APPLICANT RESPONSE TO MATTERS RAISED IN COUNCIL LETTER DATED 4 JULY 2024

We thank Fairfield City Council (Council) for their thorough assessment of Development Application (DA) 260.1/2023. This letter has been prepared by Ethos Urban on behalf of TCON Constructions to provide a response to the issues raised by Council in their letter dated 5 July 2024. The DA proposes staged development of the site involving construction of:

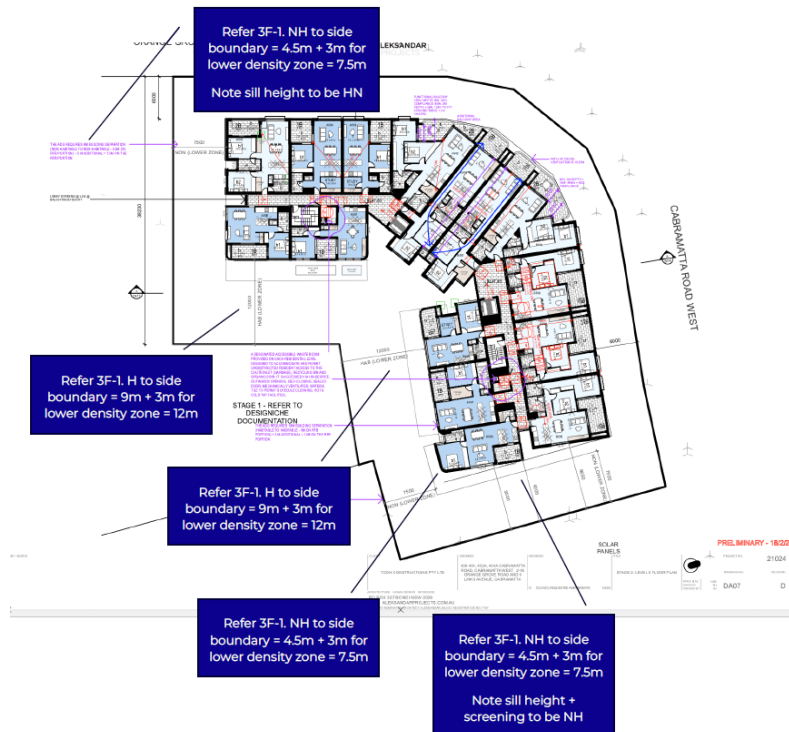
f. Third-storey of the multi dwelling housing fronting Orange Grove Road, where only two-storey is permitted, and despite reduction in amended plans to certain units, Unit 1 continues to breach the side/rear setback.	Y	<p>The LEP permits buildings up to a maximum 9m building height. The proposal complies.</p> <p>The LEP permits buildings with a maximum FSR of 0.6:1. The proposal complies.</p> <p>The three storey MDH proposed at the time of lodgement are considered appropriate and form an appropriate transition to lower density neighbourhoods.</p> <p>Notwithstanding the above, the proposed amended plans in Attachment A have redesigned:</p> <ul style="list-style-type: none"> Unit 1 to be part 1 storey, part 2 storey; and Units 2-4 to remove the attic level as so they present as a two-storey dwelling. <p>The proposed redesign ensures a gradual transition from the RFB down to the part 1 storey unit located at Unit 1.</p> <p>Unit 1 has been redesigned to be a part single and part two storey dwelling. The introduction of a single storey portion significantly mitigates the impact of this minor encroachment in terms of overshadowing, privacy and transition to the Links Avenue properties. It is noted that the setback proposed complies with a 0.9m standard side setback in the SSDCP. The first floor presents increased setback to the side boundary, approximately 2.9m at the corner and increasing from this point (given the angle of the boundary). The improved proposal does not generate adverse overshadowing (continues to receive at least 3 hours of direct solar mid-winter as per CWDCP 6A.5.1) or privacy impacts (with no windows proposed to the side wall of Unit 1).</p> <p>Furthermore, the position of Unit 1 and its separation from X Links Rd is appropriate in the circumstances and consistent with the objectives of Section 1.4.3 in the SSDCP for the following reasons:</p> <ul style="list-style-type: none"> Unit 1 complies with the Orange Grove Road setback and is part of the wider development that will enhance the established streetscape and character of the neighbourhood through the provision of a residential development that accords with the LEP.

Topic	Council matter raised	Compliant Y/N	Applicant response
			<ul style="list-style-type: none"> The portion of Unit 1 located within the setback encroachment does not contain any windows and will maintain privacy to adjoining properties. The portion of Unit 1 located within the setback encroachment avoids the use of blank facades and includes a staggered and articulated built form. This includes an increased setback towards the eastern portion of Unit 1 and a height transition from 2 storeys to 1 storeys. There is sufficient space between the dwellings to accommodate planting to increase visual separation. The landscape plan identifies sufficient space for a row of <i>Photinia Glabra</i> 'Ruberts' which can grow to a height of 3m.

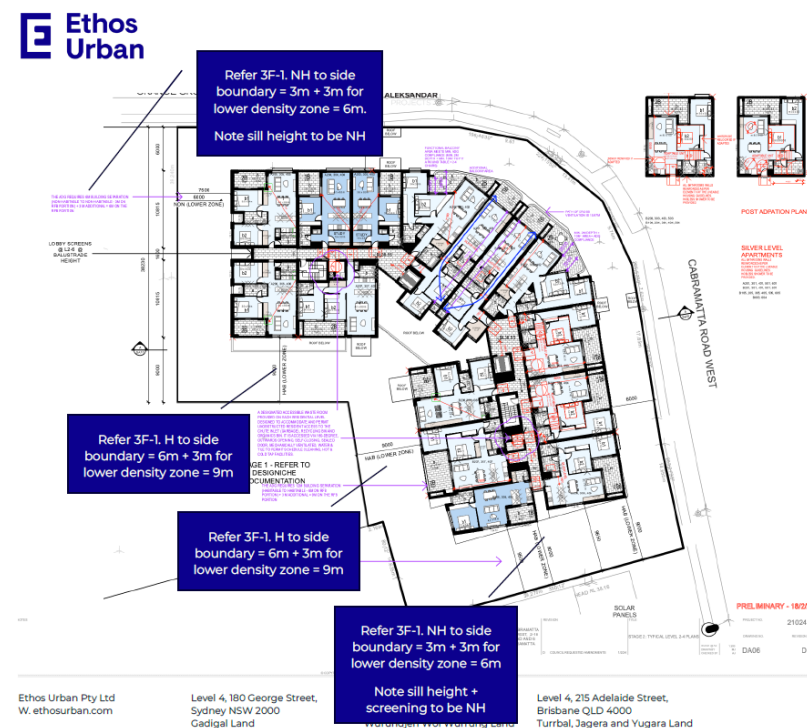
o. Building setbacks and separation requirements not met:	Y	(Refer items below).
	l. Residential flat building has not been amended and still provides 7.5m setback instead of the minimum 9m setback required by both the DCP and ADG for habitable rooms at Levels 1, 2 and 3 (i.e. 2nd, 3rd and 4th storeys) between the flat building and the R3 zoned multi dwelling housing. Furthermore, the 5th and 6 th storeys do not provide the minimum 12m setback that is required between the flat building and the proposed multi dwelling housing proposing 7.5m instead of 12m. The corridors	Y	<p>We would like to further discuss this with Council as the architect has prepared a design that meets the ADG privacy separation criteria. Below is an extract from the original RFI response.</p> <p><i>All setbacks are compliant with the ADG as illustrated below (ADG reference numbers shown). It is important to note that walls with windows at 1.8m sill height are treated as non-habitable, as a resident cannot look through a window at this height. Refer additional detail at Attachment D.</i></p>

appear to be setback 10.4m instead of 12m but are not dimensioned on the plans.

- II. Residential flat building has not been amended to provide the minimum 9m setback from the 1st to 4th storeys, nor the minimum 12m setback for the fifth and sixth storeys to the south-eastern boundary with adjoining R2 zoned properties including but not limited to No. 1 Smiths Avenue. This is required to meet the ADG control requiring a minimum 9m setback from habitable spaces to the boundary plus 3m to a lower density zone.

Refer to response (1) above.

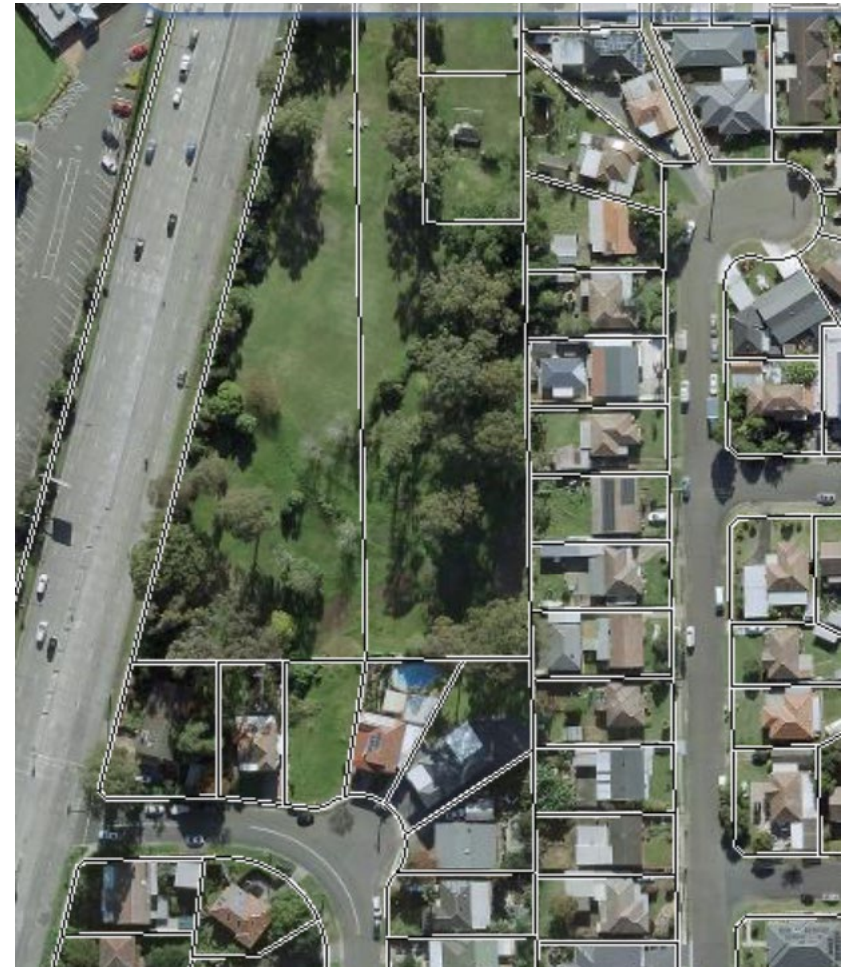
- XI. Minimum separation distances are not achieved between Unit 50 and Unit 44 at ground and first floor level and are also not achieved between Units 29 and 44.

The plans in **Attachment A** have been revised to achieve compliant separation between Unit 44/50 and Unit 44/29.
